ADDENDUM NUMBER TWO

DATE: April 1, 2019

PROJECT: City of Myrtle
Renovations to 13th Ave. South for Facilities Maintenance

Addendum 2 is being issued as a Supplement Addenda to ADDENDUM 1.

Item No. 1 - Sheet G0.0 Code Compliance

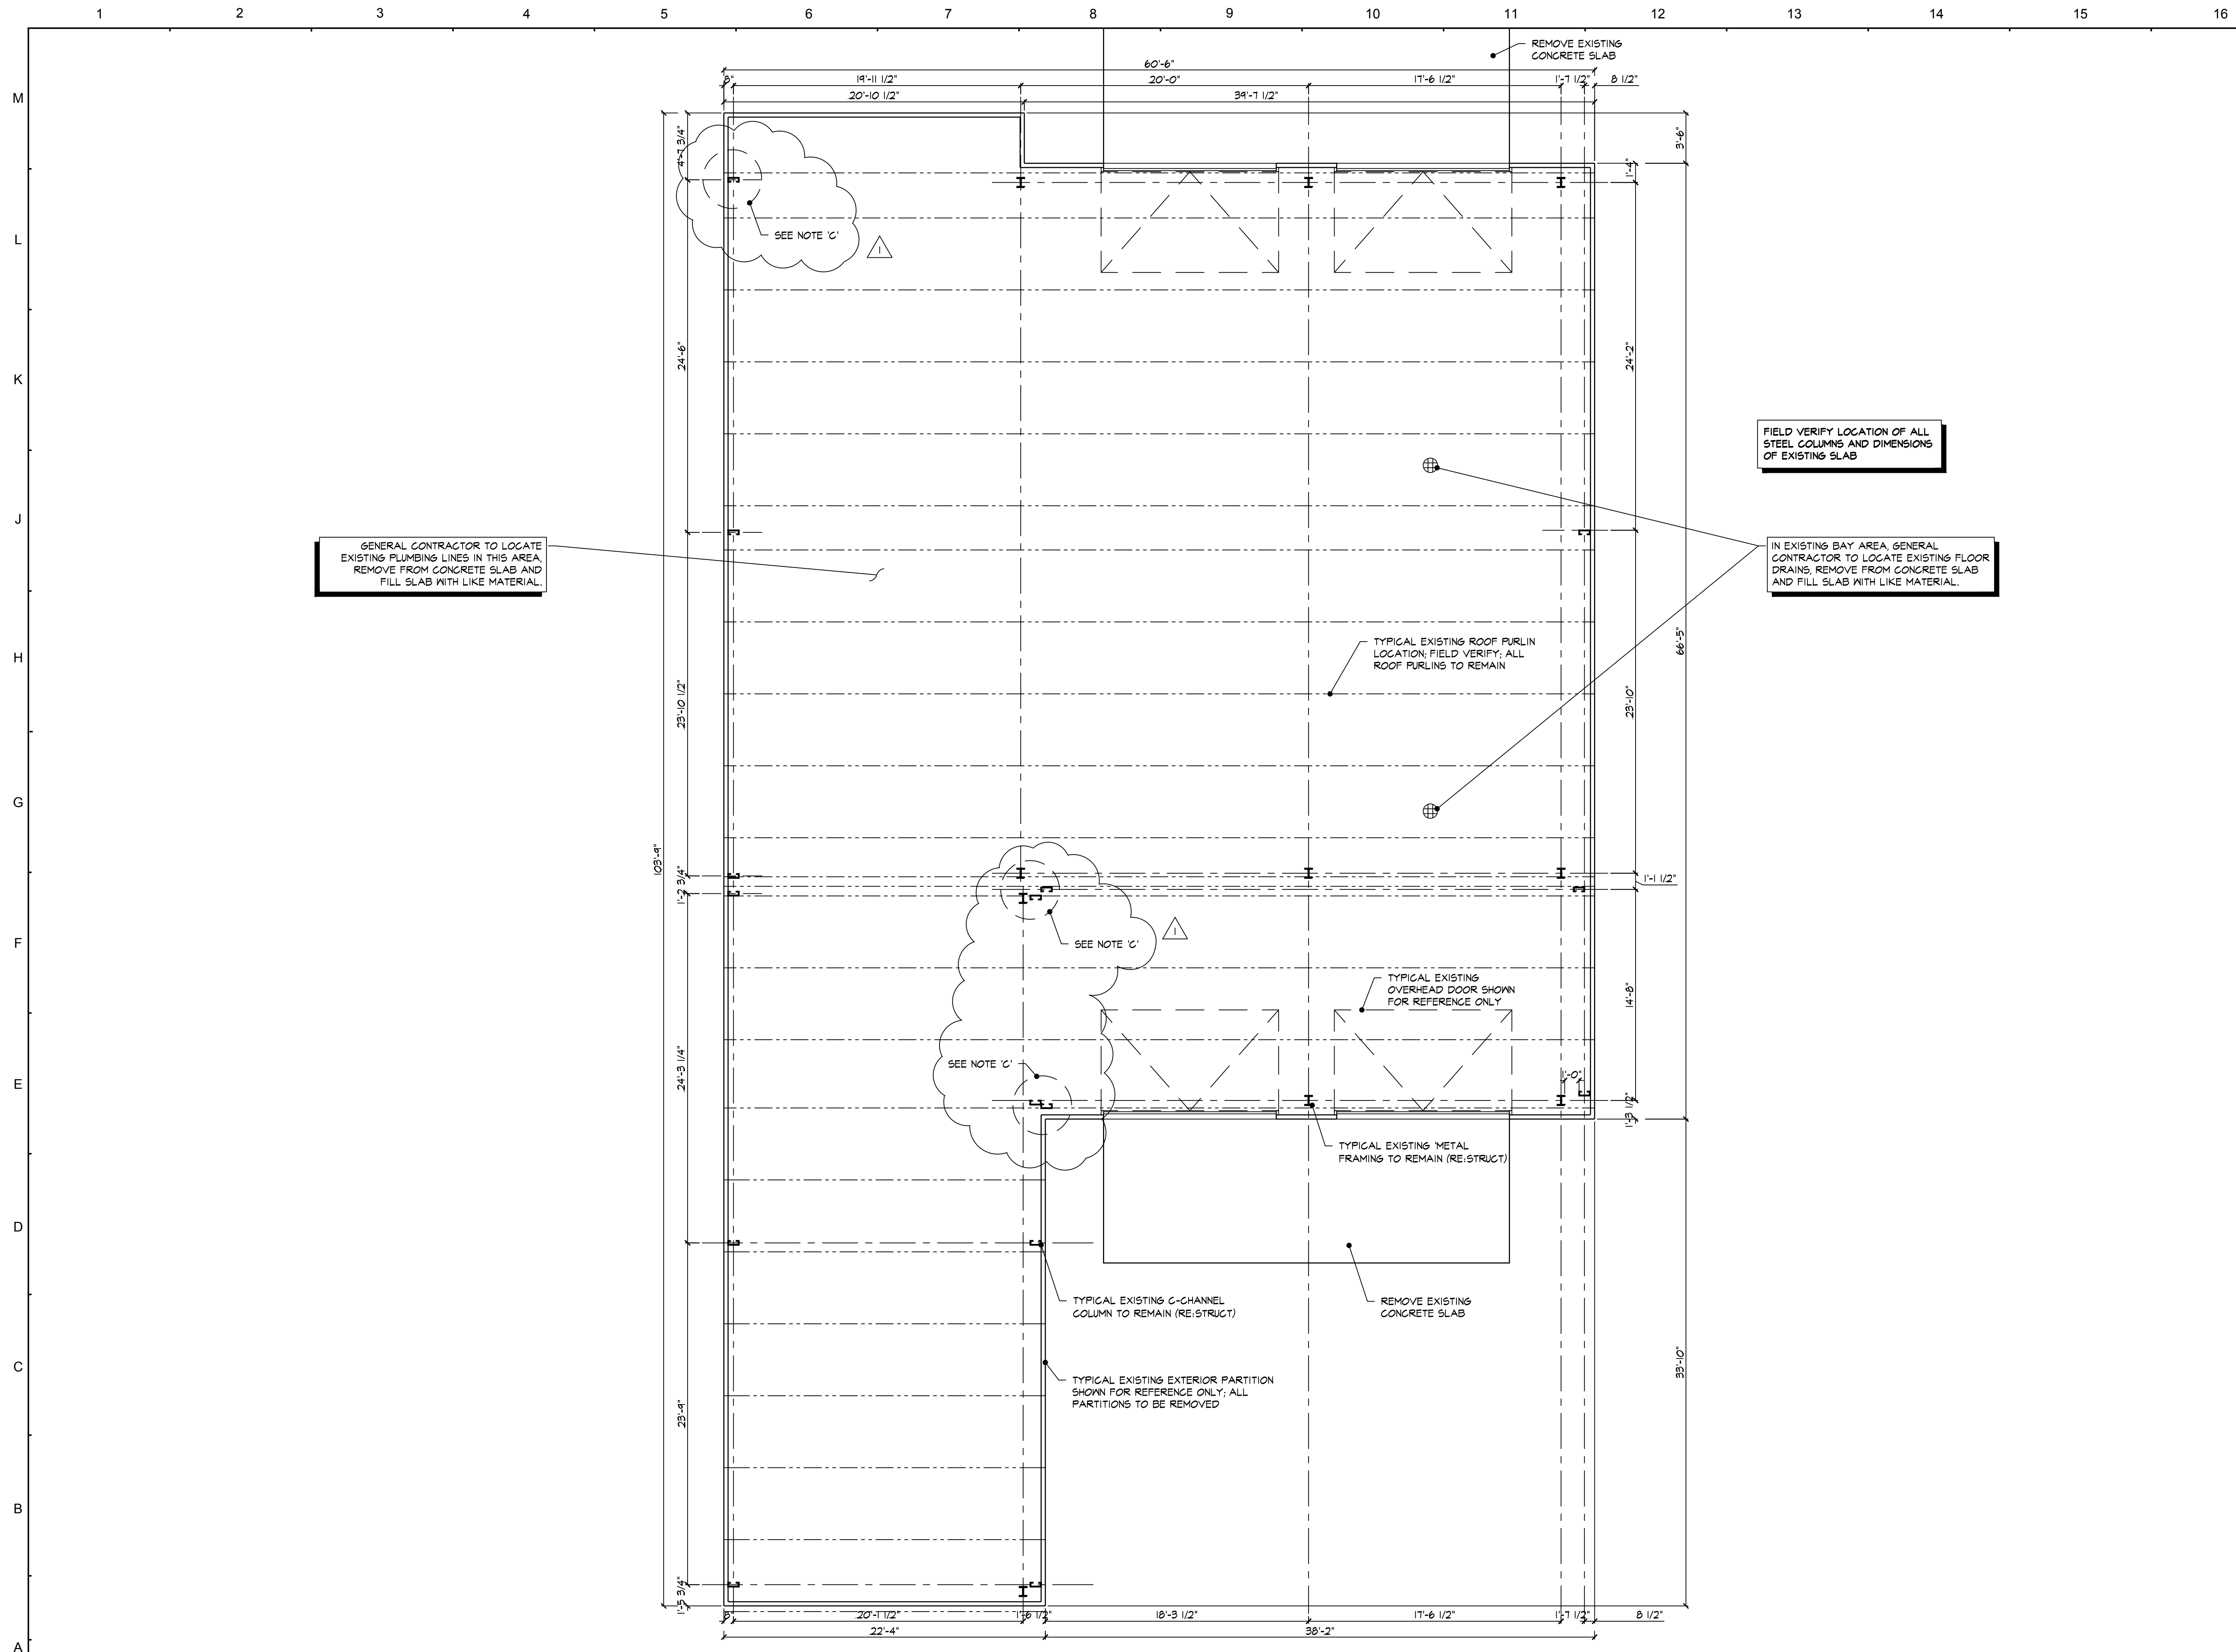
Revisions reflect Owner's Occupancy of 14 employees, and therefore, not requiring a drinking fountain.

Required	Provided
Water Closets:	Male: 1; Female: 1	Male: 2; Female: 1
Lavatories:	Male: 1; Female: 1	Male: 1; Female: 1
Drinking Fountains:	2015-IBC, Section 2902.6: Small occupancies. Drinking fountains shall not be required for an occupant load of 15 or fewer.	
Other: Service Sinks	1	1
Unisex bathrooms (watercloset and lavatory)	-	1
